Access Compliance Report

Public Rights-of-Way

(Curb Ramps)

Intersection ID: 3031	Main Street: AMBER_GLEN_DR	Cross Street: AZURE_VALLEY_PL	Location:	N
ADA ID: 515D36F4EDDA	Ramp Type: Perp	Initial Pass/Fail: Fail	Overall Compliance: No	Severity Score: 18.75
Codes/Mitigation Info/Possible Solution		Field Measurements/Component Compliance

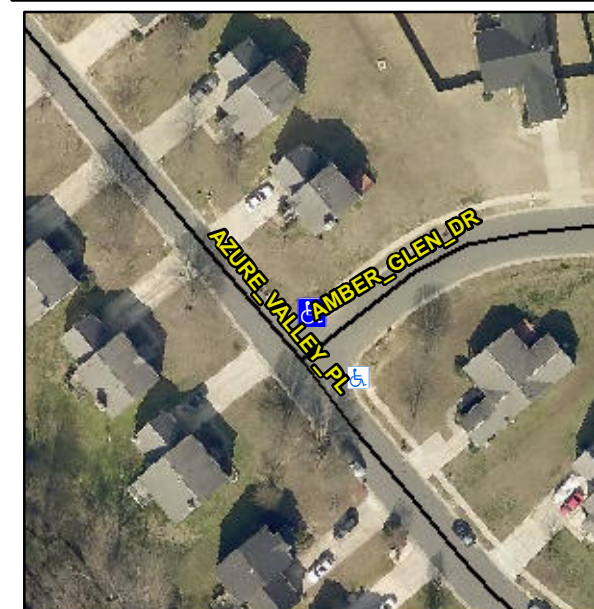
Not Found, R304.5.1, R304.5.3

Compliance	Description	Data	Compliance	Description	Data
N/A	Ramp Length (in)	51.0	Yes	Ramp Slope (%)	6.4
No	Ramp Width (in)	34.0	No	Ramp XSlope (%)	2.9
N/A	Flare Type LT	N/A	N/A	Flare Type RT	N/A
N/A	Flare Slope LT (%)	N/A	N/A	Flare Slope RT (%)	N/A
N/A	Flare Traversable LT?	N/A	N/A	Flare Traversable RT?	N/A
N/A	Landing Length (in)	N/A	N/A	DWS Provided?	N/A
N/A	Landing Width (in)	N/A	N/A	DWS Contrast?	N/A
N/A	Landing Slope (%)	N/A	N/A	DWS Length (in)	N/A
N/A	Landing X Slope (%)	N/A	N/A	DWS Full Width?	N/A
N/A	Landing Curb? (Y/N)	N/A	N/A	DWS Offset (in)	N/A
N/A	Shared Landing?	N/A			
N/A	Gutter Ponding?	N/A	N/A	Gutter Slope (%)	N/A
N/A	Gutter Lip Ht (in)	N/A	N/A	Gutter X Slope (%)	N/A
N/A	Painted X Walk1?	No	N/A	Painted X Walk2?	N/A
	X Walk 1 Direction	To SE		X Walk 2 Direction	N/A
N/A	X Walk 1 Width (in)	N/A	N/A	X Walk 2 Width (in)	N/A
	X Walk 1 Slope (%)	1.4		X Walk 2 Slope (%)	N/A
	X Walk 1 X Slope (%)	0.7		X Walk 2 X Slope (%)	N/A

Remove & Replace Entire Ramp.
